SUBJECT: Change Order No. 2 – Contract W-21-1 – Perry Ave Tank Roof Replacement

Section 00 63 63 - CHANGE ORDER NO. 2

**City of Racine, Wisconsin
2,750,000 Gallon Standpipe
Roof Replacement**

**November 7, 2021
Bulletin No. 1**

DIXON ENGINEERING, INC.	
Racine, WI 2,750,000 Standpipe	
Overflow Pipe	
Drawn By: TMF	Date: 11/07/21
Checked By: JVR	DWG: 01a

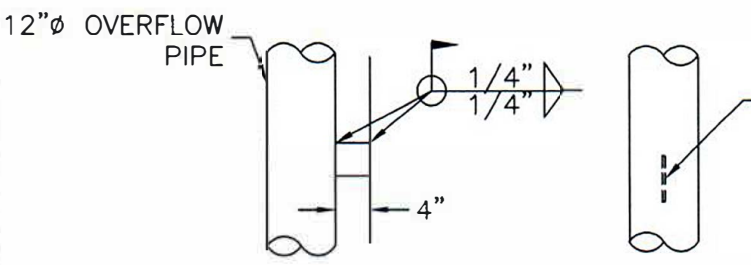
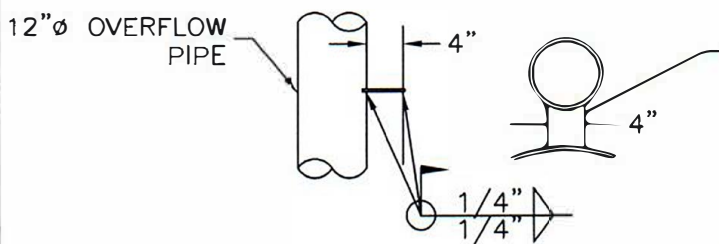
Replace the overflow pipe. Remove the existing overflow pipe including the interior elbow, existing reinforcement at the sidewall penetration, tabs and supports down to ground level. New pipe size to match the existing pipe diameter (12 inch diameter, Contractor to field verify). New pipe is to be SCH20. See attached Drawings 01a-01b for details. The pipe exterior is to be coated per the specifications, the wet interior weld burns and new pipe sections are to be coated per the specifications.

- NOTES:**
1. THE HEIGHT OF THE NEW INTERIOR ELBOW IS TO BE LOCATED AT EXISTING HIGH WATER LEVEL.
 2. OVERFLOW PIPE IS TO BE 12" IN DIAMETER SCH. 20.
 3. THE OVERFLOW DISCHARGE IS TO EXTEND 3 FT. AWAY FROM THE SIDEWALL.

Racine, WI 2,750,000 Standpipe	
Overflow Discharge	
Drawn By: TMF	Date: 11/07/21
Checked By: JVR	DWG: 01b

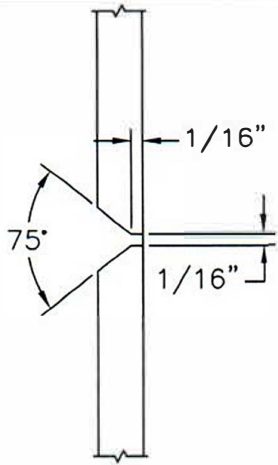
INSTALL A SCH 20 PIPE SECTION TO DISCHARGE 3 FT. BEYOND THE SIDEWALL,

GALVANIZED STEEL NUTS AND BOLTS. SIZE PER AWWA C207

MIN. 1/4" FLANGE WITH BOLT HOLES PATTERN PER AWWA C207

STAINLESS STEEL 24 MESH SCREEN
